January 30, 2014
NRC:14:004

Potential Non-Conservatism in NRC Branch Technical Position 5-3

Discussion of Potential Non-Conservatism in NRC Branch Technical Position 5-3

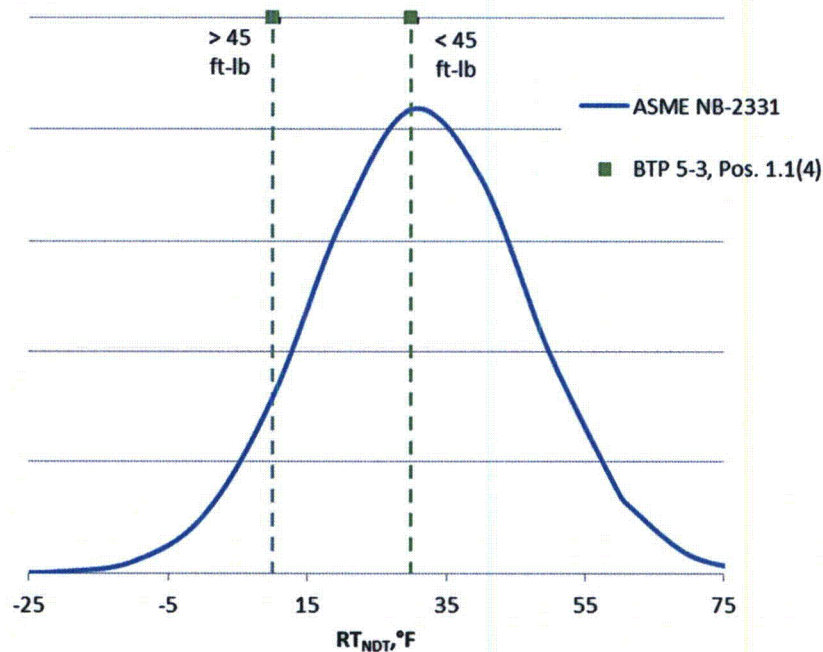
RT_{NDT} values from B&W procured RPV forgings were determined according to ASME NB-2331 and estimated per Paragraph 1.1(4) of Reference 2. The below comparison shows that use of RT_{NDT} as estimated according to Paragraph 1.1(4) of Reference 2, with $\sigma_i = 0$, does not result in a bounding estimate of RT_{NDT} before irradiation, as stated in Reference 3 above.
